Subject: **Sequoyah Nuclear Plant – Response to Request for Supplemental Information (D-RSI) Request for Exemption from Non-Destruction-Examination Compliance (EPID No. L-2022-LLE-0027)**

TENNESSEE VALLEY AUTHORITY (TVA)
SEQUOYAH NUCLEAR PLANT (SQN)
INDEPENDENT SPENT FUEL STORAGE INSTALLATION

TVA RESPONSE TO REQUEST FOR SUPPLEMENTAL INFORMATION

Figure 1: Location Markers on Longitudinal Weld

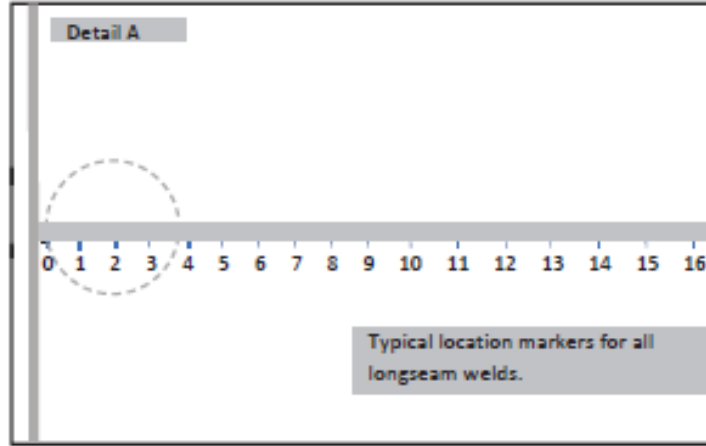
Provide the following supplemental information on the original shell-to-shell longitudinal weld, the radiography testing (RT) results that identified a defect located in the shell-to-shell longitudinal weld between 4 to 14 inches from the bottom of the multipurpose canister (MPC) baseplate, and the method used in the repair weld.

- (a) Describe the welding process used for the original weld.
- (b) Describe the original RT results that identified the initial defect(s) located between 4 to 14 inches from the bottom of the MPC baseplate including the size, location, orientation, and type of defect(s).
- (c) Describe the original weld joint geometry and a sketch or detailed dimensions of the weld excavation.
- (d) Describe the welding process was used for the first repair weld.

The applicant provided that the original RT identified a defect which located in the shell-to-shell longitudinal weld between 4 to 14 inches from the bottom of the MPC baseplate. The applicant stated that this defect required an excavation of approximately 6.5" long, 5/8" wide, and 9/32" deep. However, it is unclear where the defect was located with respect to the original joint configuration. In addition, the welding process used for the repair weld is not described in the exemption request.

- (a) The original weld was welded from both sides using the submerged arc welding (SAW) process utilizing WPS-227HC. SAW is a welding process that involves the formation of an electric arc between a continuously fed consumable electrode and the workpiece. The molten weld pool is shielded from the atmosphere beneath a blanket of powdered flux.
- (b) The initial RT identified 3.7 inches of lack of fusion within view 0-1 for Weld No. 21 which is located approximately 4 to 14 inches from the bottom of the MPC baseplate with 0 being at the toe of the circumferential weld as illustrated in Figure 1 on the following page.

Figure 4: MPC shell-to-shell joint after excavation of the weld defect

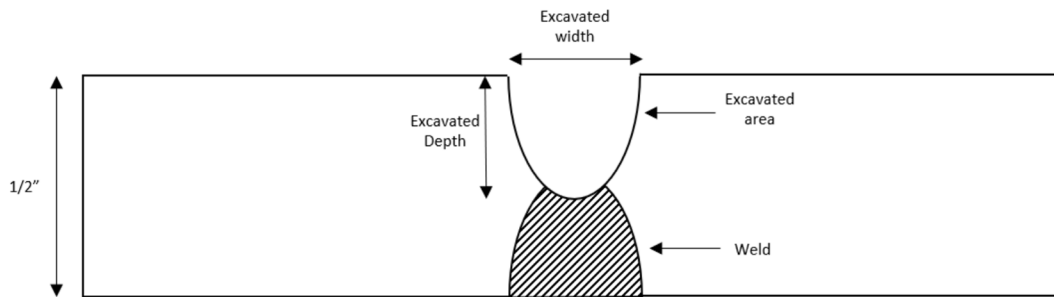
- Describe the original and repair weld joint geometry and a sketch or detailed dimensions of the weld excavation between 8.5 to 25 inches from the bottom of the MPC baseplate.

- (d) The repair of the MPC shell-to-shell longitudinal weld involved the excavation of the weld defect from a single side using mechanical means (grinding). A sketch of the shell-to-shell joint after excavation of the weld defect is displayed in Figure 4. Once the defect was verified to be removed through visual and liquid penetrant examination, the excavated area was blended uniformly into the surrounding surface with not less than a 3:1 taper and re-welded using the gas tungsten arc welding (GTAW) process utilizing WPS 47HC. GTAW is a welding process that involves the formation of an electric arc between a non-consumable tungsten electrode and the workpiece. During welding the weld filler wire is manually fed into the molten weld pool to create the weld. The molten weld pool is shielded from the atmosphere using inert gas (Argon). The weld repair area is examined by the method(s) Visual (VT), Liquid Penetrant (PT) and RT that originally disclosed the defect.

- (d) The original MPC shell-to-shell longitudinal weld joint was a double V-groove. See Figure 2 for additional details. A sketch of the shell-to-shell joint after excavation of the weld defect is displayed in Figure 4. Refer to Weld No. 21 on Figure 5 (MTR 12306-667) for dimensions of the weld excavation area.
